### **OFF-SITE DOSE CALCULATION MANUAL CHANGES**

Doc No.: PMP-6010-OSD-001  
Title: OFF-SITE DOSE CALCULATION  
MANUAL

Rev 026  
No.:

Alteration Cat.: Major Revision - Full Review  
CDI/50.59:1 EC-0000053363  
CDI/50.59:2 EC-0000053364

Information	PMP-6010-OSD-001	Rev. 26	Page 98 of 98
OFF-SITE DOSE CALCULATION MANUAL			
Attachment 3.23	Off-Site Monitoring Locations - REMP		Page: 98

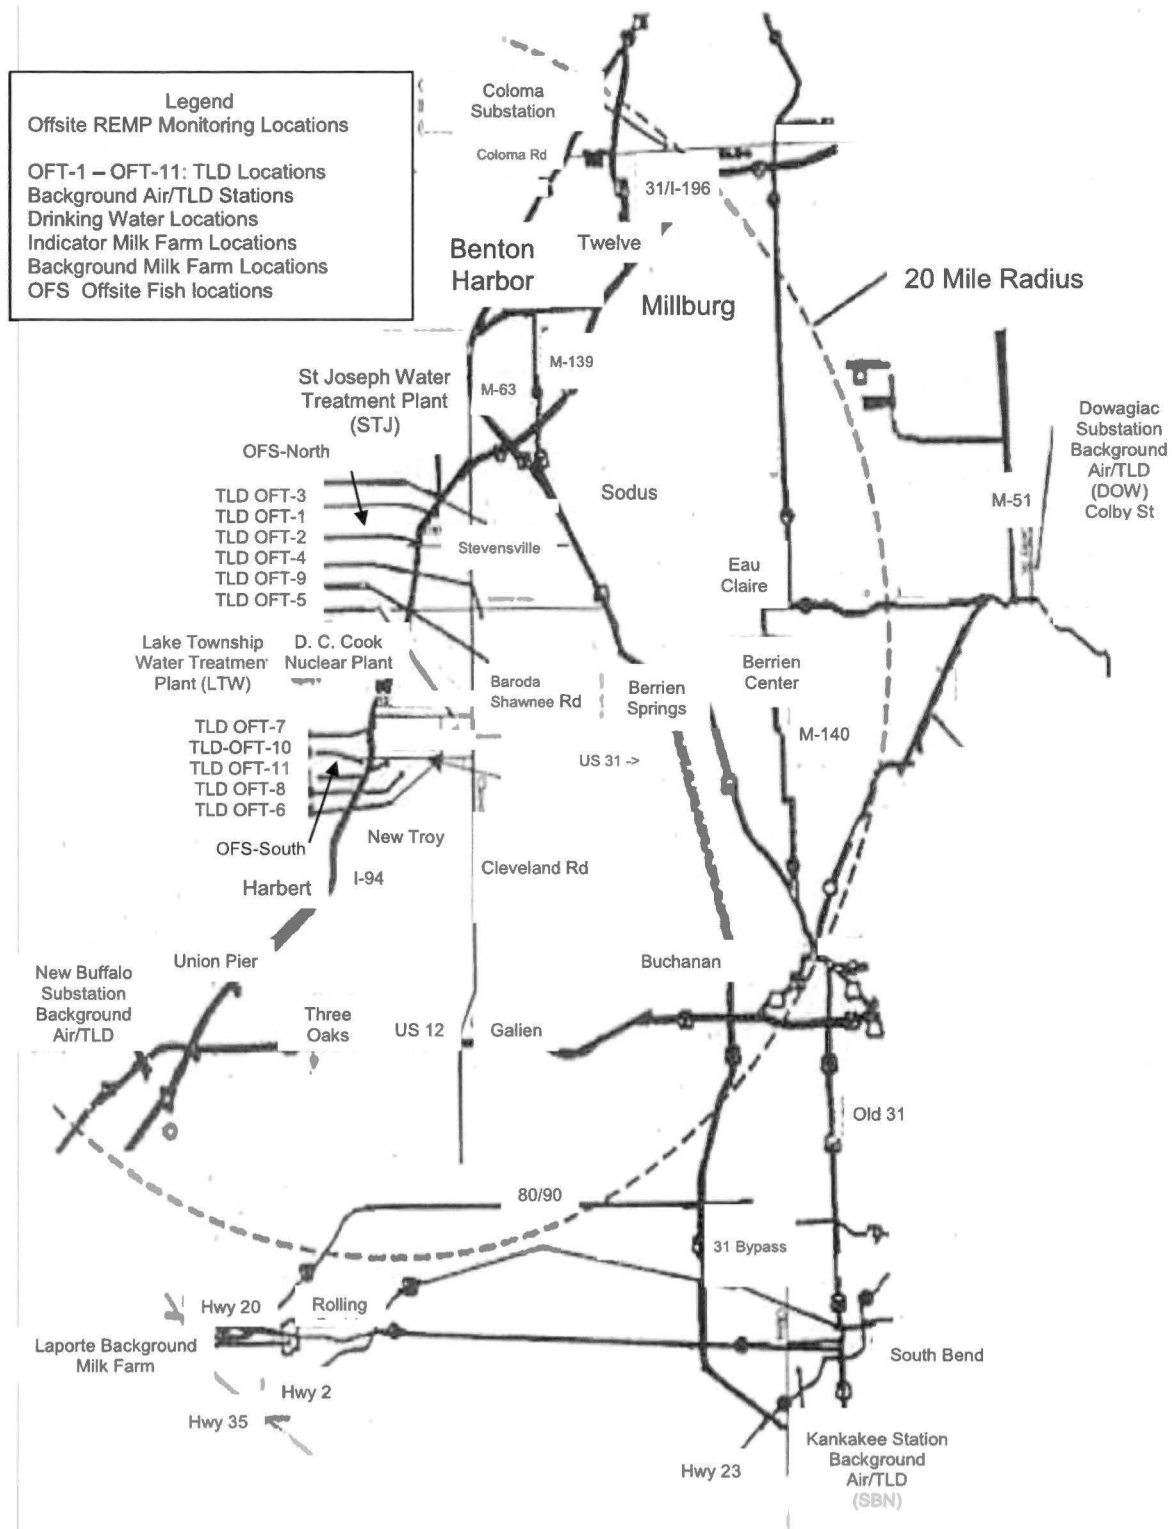
Page 33, Step 3.3.2 b.1, should read vent stack noble gas channels to consistent with step 3.3.2 c.1 on page 34. Ensure the Att. 3.23 Map copies correctly
Comments provided to the procedure writer.
